REMARKS

AMENDMENTS TO THE DRAWINGS

**FIG. 9A****FIG. 9B****FIG. 9C****FIG. 9D****FIG. 9E****FIG. 9F**

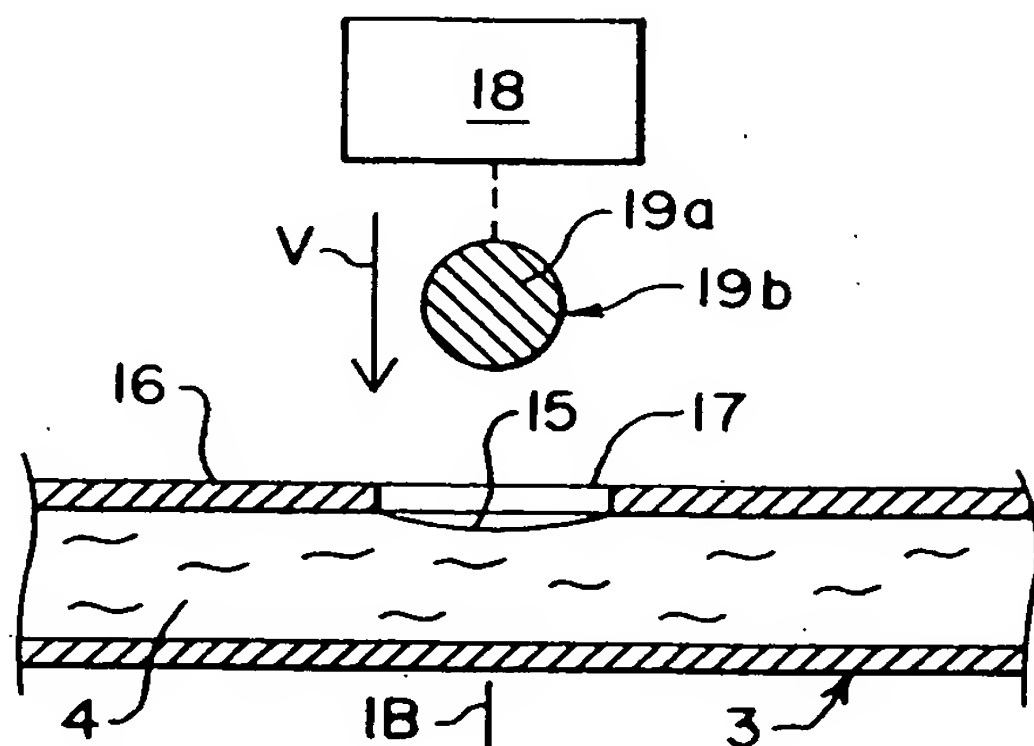
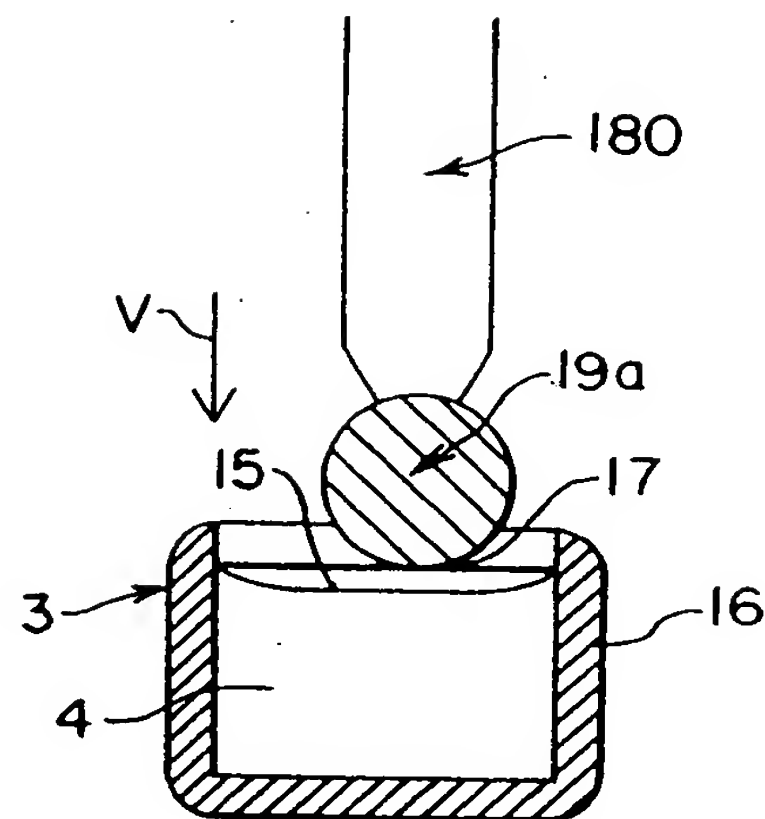
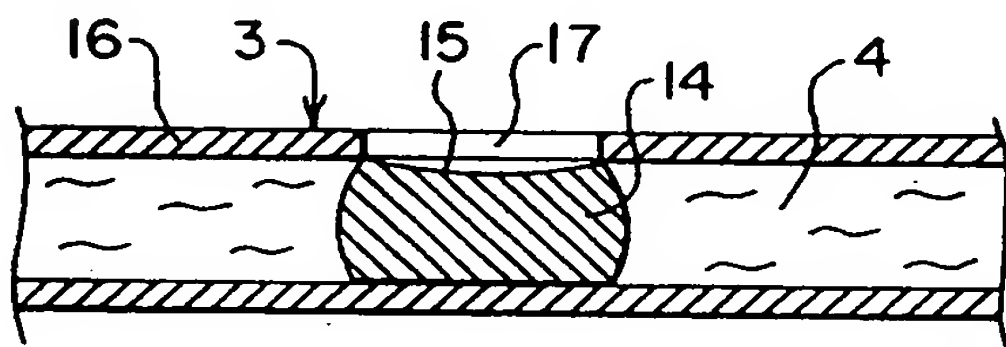
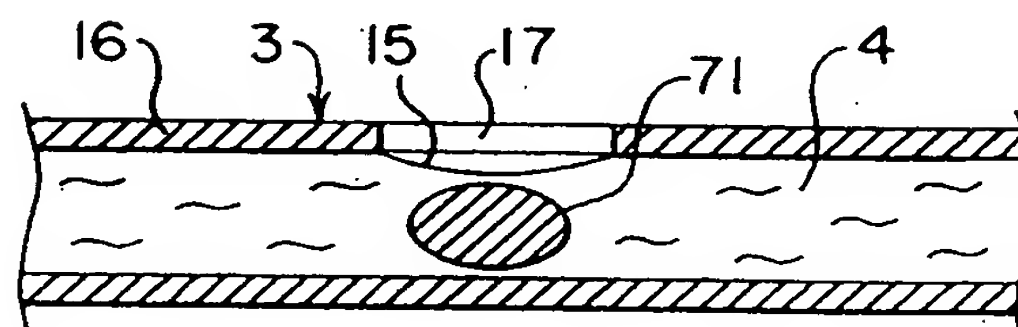
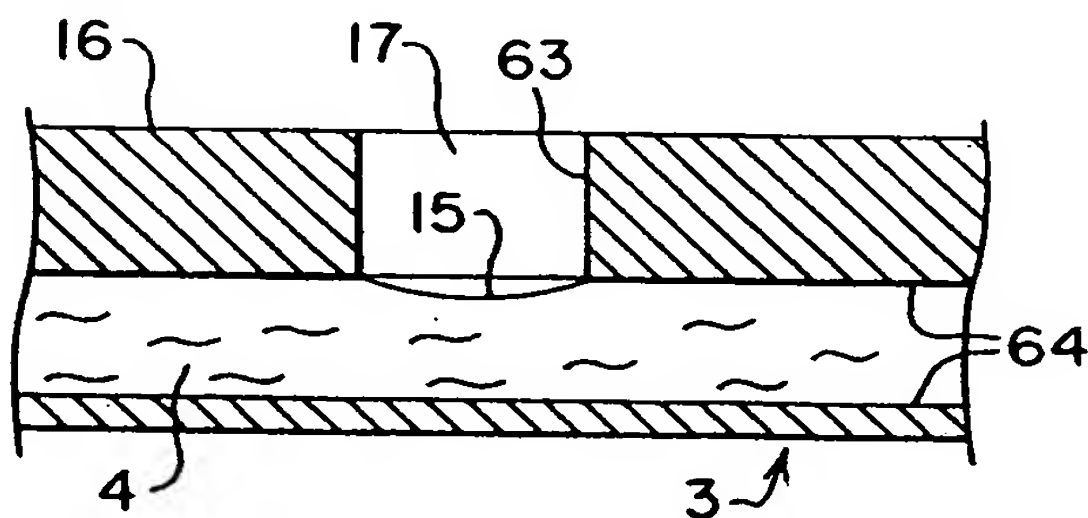
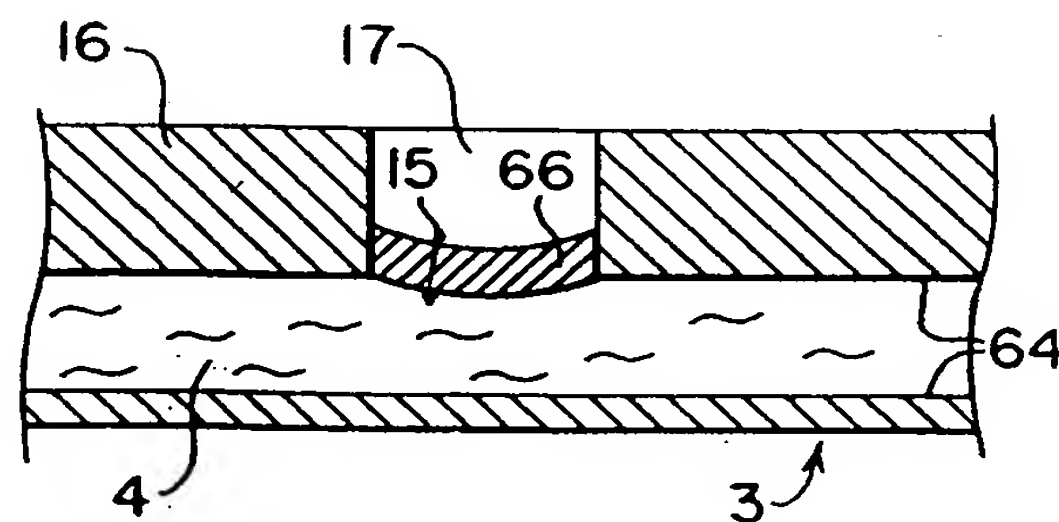
Regarding the objection to the drawings for failing to comply with 37 CFR 1.84(p)(5), Applicants have amended the drawings and specification to address the Examiner's concerns. Specifically, Applicants have amended the paragraph describing Figure 11c, beginning on page 28, line 29 and extending to page 29, lines 8 to change the phrase "targeting electrode 61" to --targeting electrode 60--, which is consistent with Figure 11c. Applicants also amend Figure 11A to include reference sign 57, Figure 11B to include reference signs 15 and 17 and Figure 18 to include reference sign 181. In addition, Applicants amend Figure 9F to move the reference arrow for virtual wall 15 to point to the lower meniscus forming the virtual wall, rather than the encapsulant 66.

The attached three sheets of drawings include changes to Figures 9F, 11A, 11B and 18. These sheets, which include Figures 9A-9F, 11A-11C and Figure 18, respectively, replace the original sheets including Figures 9A-9F, 11A-11C and Figure 18.

Corrected drawing sheets with the corrections marked in red are attached to this Response. Replacement sheets incorporating the corrections are also attached.
